Data Sheet (SPRS953e) p195, Fig 5-4

Figure 5-4. vddshv* Supplies Falling After vdds18v Supplies Delta

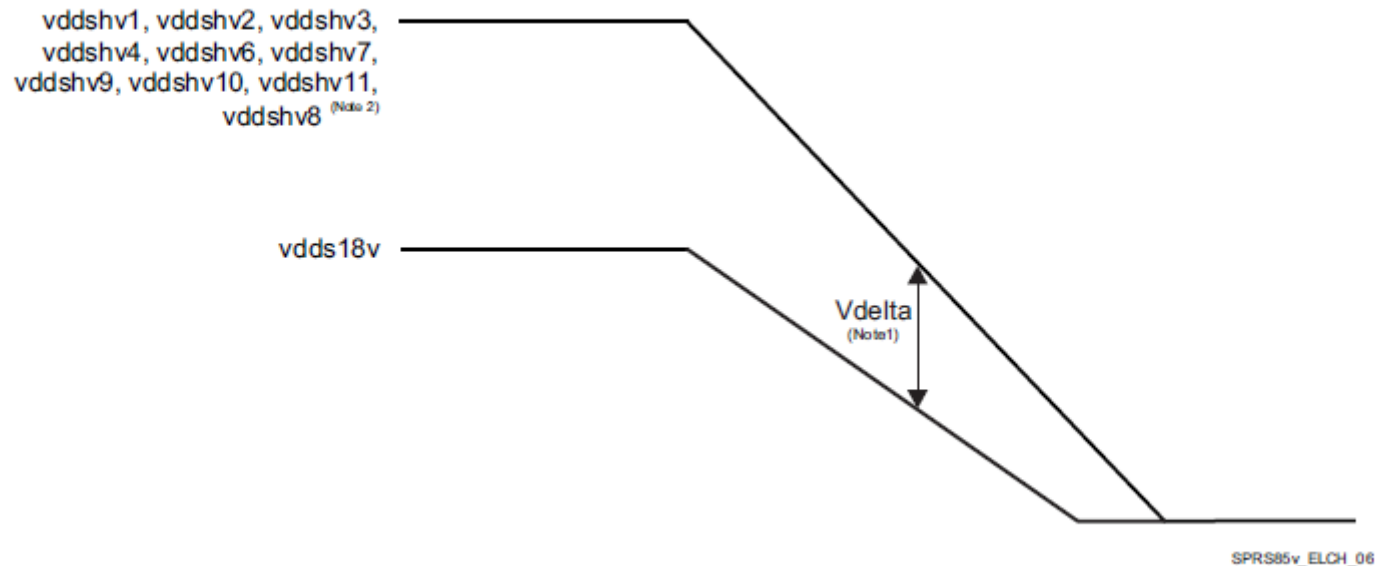
Figure 5-4 describes vddshv[1-7,9-11] Supplies Falling Before vdds18v Supplies Delta.

The following circuit diagram was created for the falling sequence.
Is there a problem with the connection?
